Response to NRW Comments

197424-F01 Rev B | 1st October 2024

Unit 1, MPN House, The Ponds, Ynyscorrwg Road, Glyncorrwg, Port Talbot, SA13 3EA

Figure 1 – Modelled 1 in 100 +CC year depth at the location of the proposed building

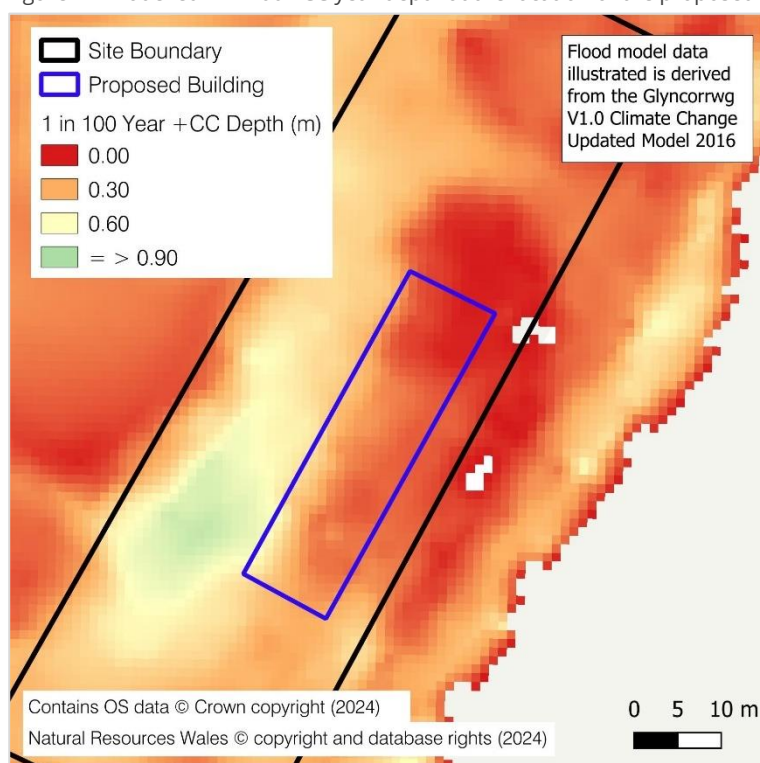
'The FCA has failed to demonstrate compliance with A1.14 of TAN15 in that the site is at fluvial flood risk in the 1%+CC fluvial flood. Whilst the site is also impacted in the 0.1% fluvial flood, the flood depths are within the tolerances of A1.15.'

Figure 1 illustrates the modelled flood depths at the location of the proposed building at the 1 in 100 +CC year event. As shown in Figure 1, flood depths are shown to be less than 300mm within the majority of the location of the proposed building.

The Finished Floor Level (FFL) of the proposed building should be raised to a level of 209.92mAOD. This is the maximum modelled flood level at the location of the proposed building at the 1 in 100 +CC year event. This will ensure the building remains flood free during this event. Flood resilience measures would also be integrated into the building's design up to a level of 210.39mAOD, which is the maximum modelled flood level at the location of the proposed building at the 1 in 1000 year event plus a 0.3m freeboard. This provides a greater level of freeboard above the 1 in 100 year +CC event for additional protection.

Figure 2 – Area available to provide compensatory storage

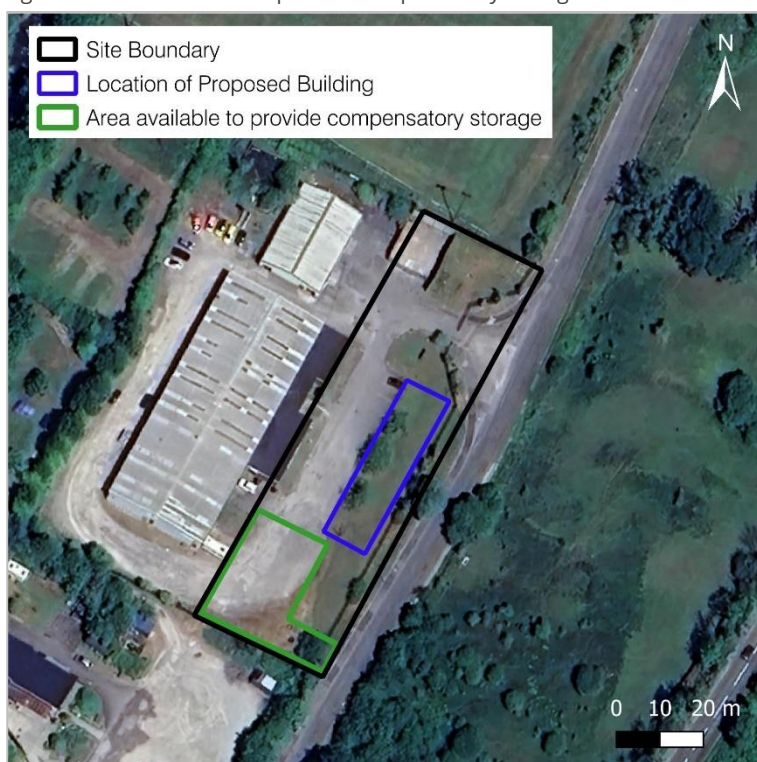
'Given the fluvial flood risk to the site any new built development has the potential to cause an increased flood risk elsewhere, the FCA has failed to demonstrate compliance with Table A1.12 of TAN15 in relation to this matter.'

Based upon the proposal to set the internal finished floor level (ground floor) at 209.92mAOD, this would potentially cause a minor increase in displacement of flood water should such a flood event occur. Fortunately, an area directly to the south-west of the proposed development footprint and to the south of the proposed attenuation basin is available to provide compensatory flood storage should such an event occur. Figure 2 below demonstrates the location and extent of this area.

Based upon the close proximity of this area to the proposed development, and the large footprint that is available to be utilised within the wider site boundary, a cut and fill exercise would be undertaken to ensure a like for like volume of compensatory storage is made available at the 1 in 100 year +CC flood event. This exercise would be completed prior to commencing construction of the development and can be conditioned.
